**Service Letter No. LH3600-9A-1
Installation of the LH3600-9A-1S Retrofit Kit
Model GLH3000 and LH4000 Skis**

This service letter only applies to the LH3600-9A cylinders.

Left to right: LH3600-9, GLH3000-9, and LH3600-9A

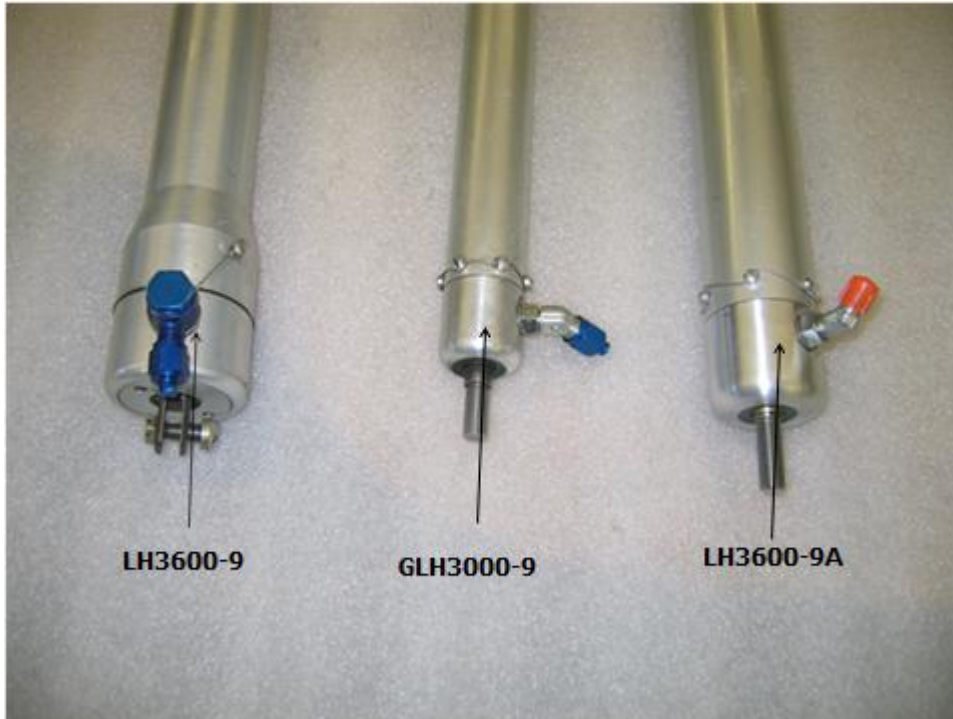
Airglas, Inc. has utilized two different hydraulic cylinders on its LH4000 skis and two different cylinders on its GLH3000 skis. Current production skis share the same LH3600-9A cylinder. To identify the cylinders refer to the photo below.

Airglas, Inc. incorporated an improved design of the LH3600-9A hydraulic cylinder on production LH4000 and GLH3000 skis. This design change improves the retention of the end caps.
